INDESIT company

Model type:
LV640AWH

Commercial code:
F029943

n1045069: Modification of racks and dispenser lid on EVO3 dishwashers

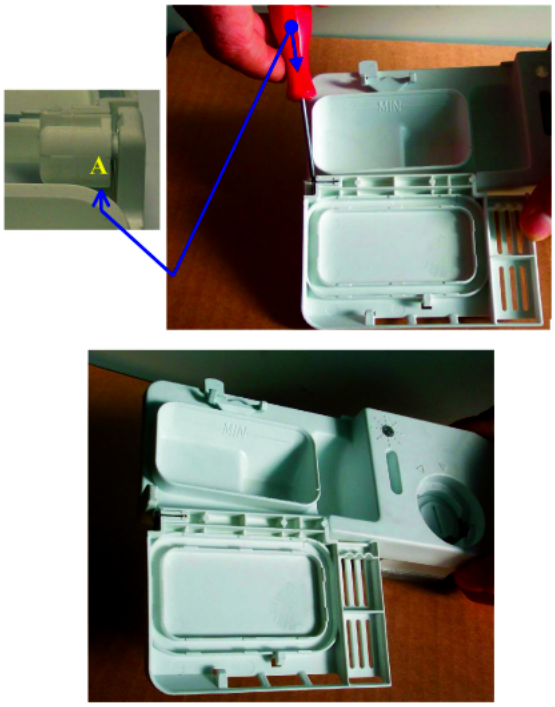
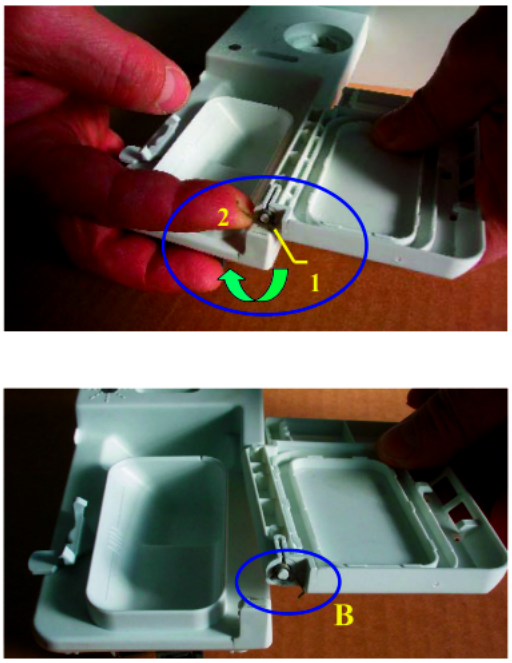
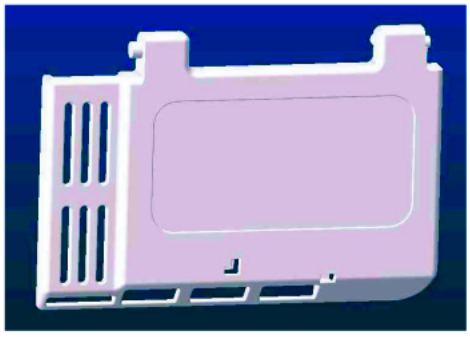
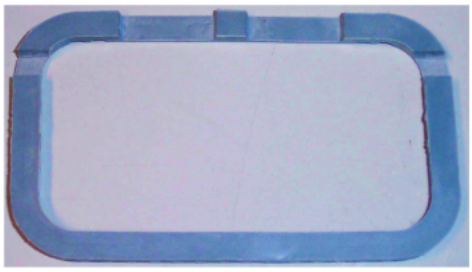
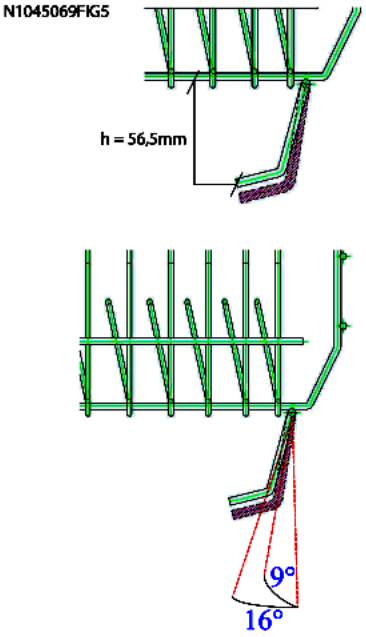
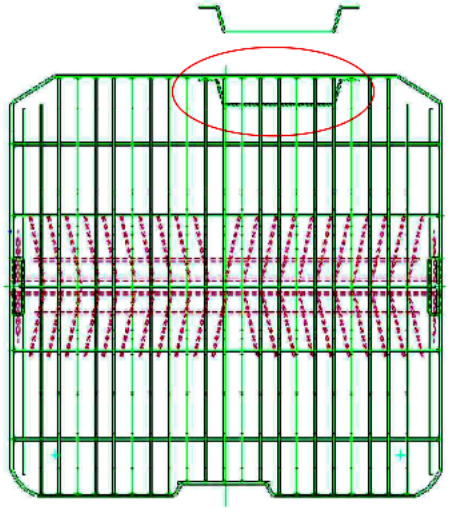
To obtain better dissolving of the detergent during the wash cycle, the following modifications have been made to EVO3 dishwashers:
- new dispenser lid, replacement code 098134 (see figure N1045069FIG4) created;
- upper racks modified with lid catch angle changed from 9° to 16° (see figure N1045069FIG5);
- MultiSystem lower racks modified with insertion of a spacer wire at the electric dispenser (see figure N1045069FIG6).

Lid installation instructions:
1) prise the lid out of the dispenser seat using a small screwdriver at point A (figure N1045069FIG1);
2) replace the lid, checking that release spring B (figure N1045069FIG2) is in place; before fitting the new lid load the spring from position 1 to position 2 (figure N1045069FIG2);
3) fit the lid in its special seat and check for correct operation (figure N1045069FIG3).
Lid closing may be harder for the first few cycles after replacement, due to settling of the material.

The upper and lower racks have the same spare part codes as the premodification items; Replacements Warehouse stocks have been replaced.

N1045083FIG1

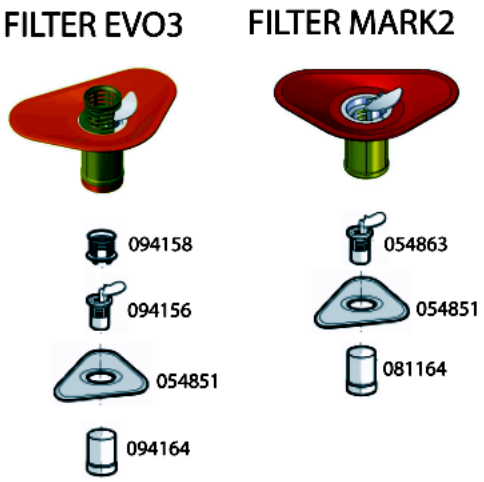
All dishwasher models affected by this modification have been equipped with the items listed below, in order to solve the drain pump clooging problem.

Introduction of:
Cylindrical plastic filter code 081164
Central filter code 054863

Elimination of:
Cylindrical plastic filter code 094164
Central filter code 094156
Central filter grid code 094158

The modification has been introduced progressively, starting from serial no. 40516.0001.

n1045085: Introduction of new litre counter turbine integrated on air-break.

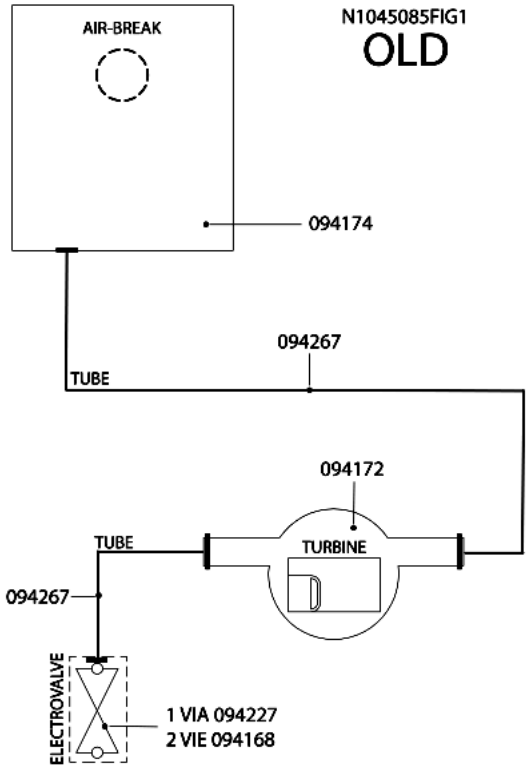
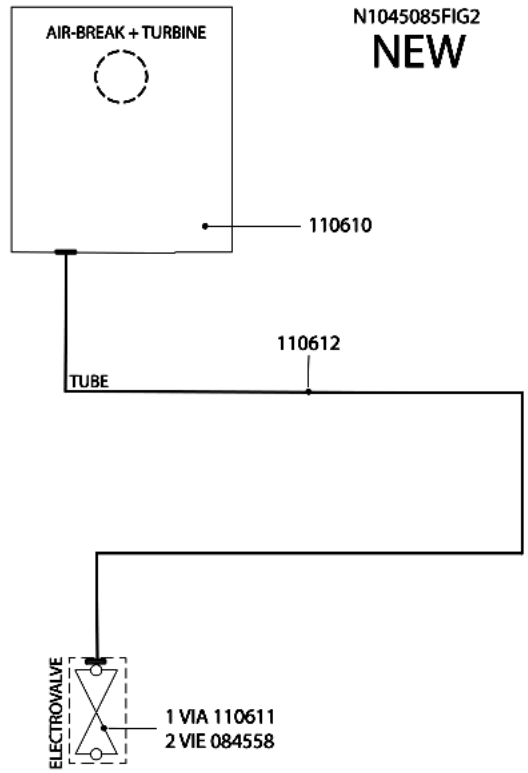
All dishwashers affected by this note have been equipped with a new litre counter turbine on the air-break.
Picture N1045085FIG1 illustrates the premodification structure, picture N1045085FIG2 the new structure.

AIR-BREAK:
new 110610;
premodification 094174;
the new item features a new integrated litre counter turbine and its water supply hose has a smaller diameter.

SOLENOID VALVES:
new:
1-WAY code 110611;
2-WAY code 084558(Rohs 143737);
premodification:
1-WAY code 094227;
2-WAY code 094168;
the new solenoid valves have a smaller diameter drain hose fitting.

HOSES:
new solenoid valve hose/air-break code 110612;
premodification turbine hose/air-break code 094267;
premodification solenoid valve hose/air-break code 094267;
the new hose has a smaller internal diameter.

WIRING:
the litre counter turbine connecting cable is longer, but since the connector is the same, the new item can be used in place of the premodification one.

N1045093FIG1
NEW FLAP UPPER BASKET SAT CODE 114799

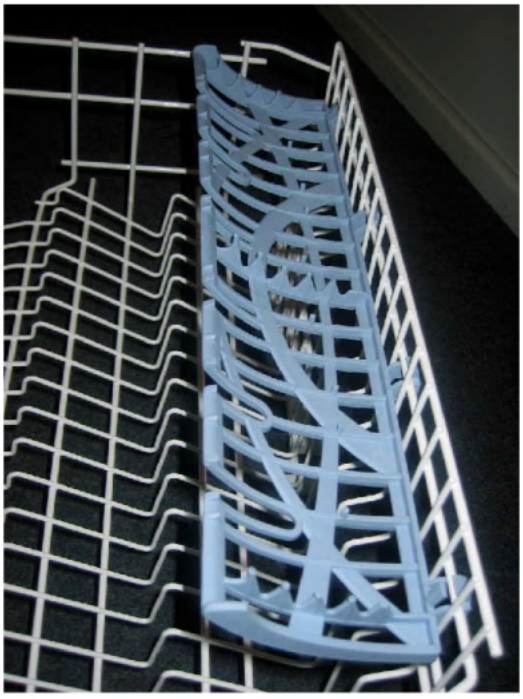
From serial no. 41109.0001 all models affected by this bulletin feature a modification of the folding shelf to upper basket coupling system.
This modification called for alteration of the relative baskets: the distance between the wire on which the folding shelf is attached and the wire below it has been increased from 9.5 mm to 17 mm, as shown in the attached image.
The altered folding shelves are not interchangeable and cannot be installed on premodification baskets: in the case of service interventions on product with serial number prior to 41109.0001 the entire upper basket must be replaced.
The baskets are reciprocally interchangeable and are managed as assemblies complete with their accessories, inclusive of folding shelves.

UPPER BASKET LIGHT BLUE FOLDING SHELF
new 114799 - premodification 094140.

UPPER BASKET ASSEMBLIES
new 115001 - premodification 094139;
new 115002 - premodification 094222;
new 115003 - premodification 094233.

N1045076FIG1

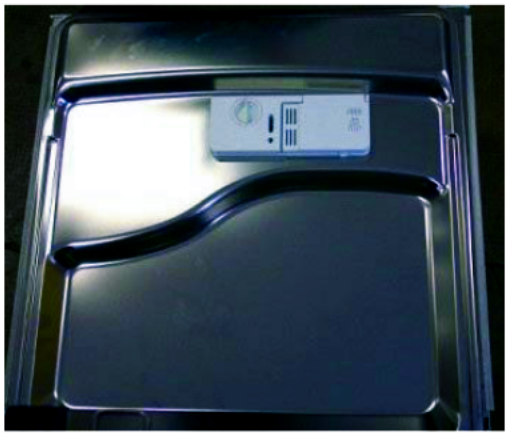
From serial number 50930.0001, to solve the problem of water spurts emitted from the lower right and left side of the door the following modifications were introduced in production:

1-Airbreak without insert to allow the necessary pressure venting

2-Honeycomb top panel to protect the kitchen unit from any steam emitted (only on built-under models)
3-Tank seal length increased by 3 cm to improve water tightness
4-Die-cut roof sound-deadening panel
5-Three clips for correct fixing of the tank base seal (in production from serial number 50701.0001)

1) AIRBREAK REPLACEMENT
It is mandatory to use the new part; in the event of replacement with premodification appliances proceed as follows:
- replace the airbreak with the new part C00141308
- if present, refit the roof sound-deadening panel after cutting out a 10x10 cm square from the rear left-hand corner
- on the built-under version, fit honeycomb panel C00141310 on the top of the appliance
- replace tank seal with the new seal P/N C00141317

2) CHANGING THE TANK SEAL
On appliances with serial number from 40101.0001 to 50930.0001, you can use the new tank seal P/N C00141317 after cutting 1.5 cm off each end.

N1045133/134FIG1

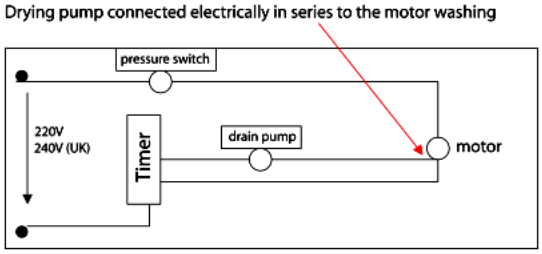
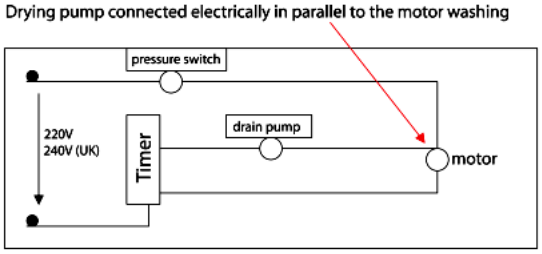
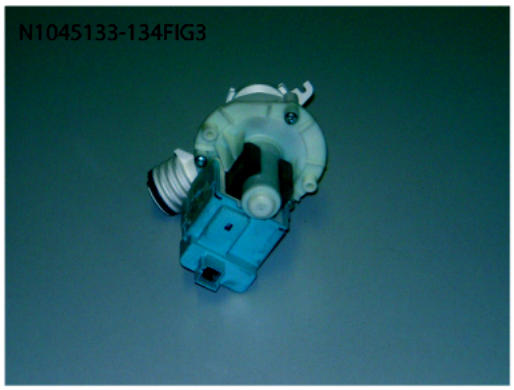
The drain pump electrical connection has been modified from a configuration in series with the wash electric pump to one in parallel.

The drain pump in series with the wash electric pump is fed through the wash electric pump causing a voltage drop equal to -15V (diagram N1045133-134FIG1).

The drain pump in series with the wash electric pump is electrically fed directly by the F-N line, without any voltage drop (diagram N1045133-134FIG1).

Important!!
The thermoprotected drain pump cannot be installed on premodification dishwashers.
The non-thermoprotected drain pump cannot be installed on modified dishwashers.

N1045136FIG1

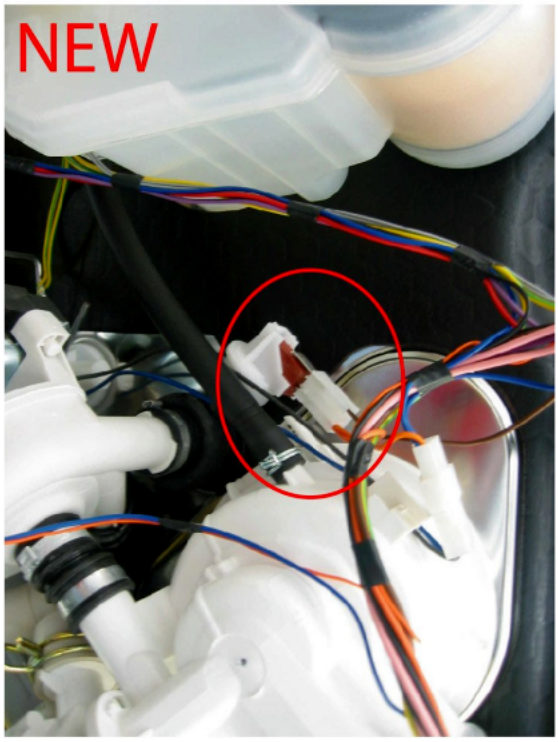
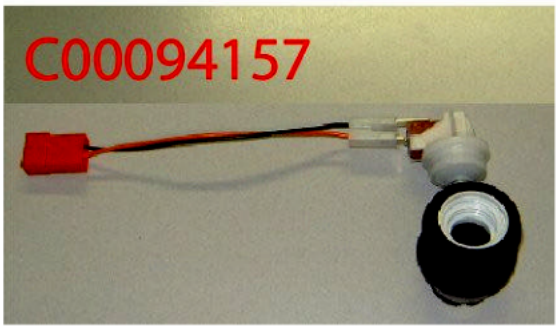
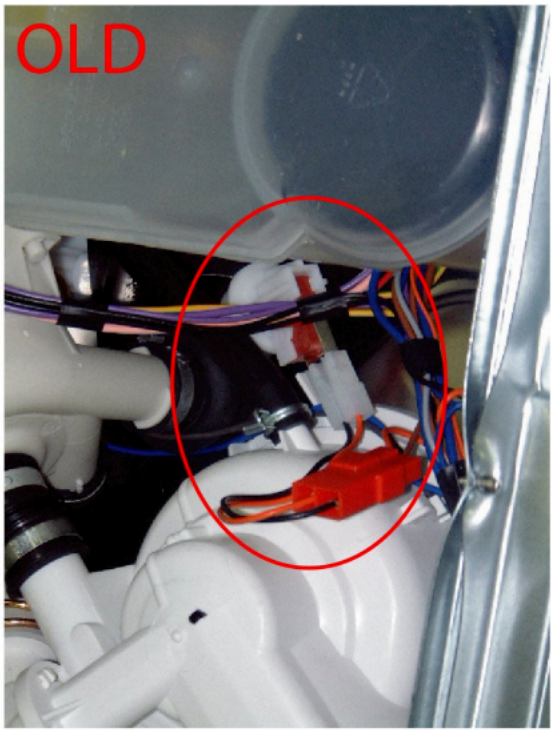
In modified products the connector going to the high pressure sensor is part of the wiring assembly (see picture N1045136FIG1). In premodification products the high pressure sensor is connected to the wiring assembly by a cable that is part of code C00094157 (see pictures N1045136FIG2-3).

The new parts are not individually interchangeable with premodification ones.
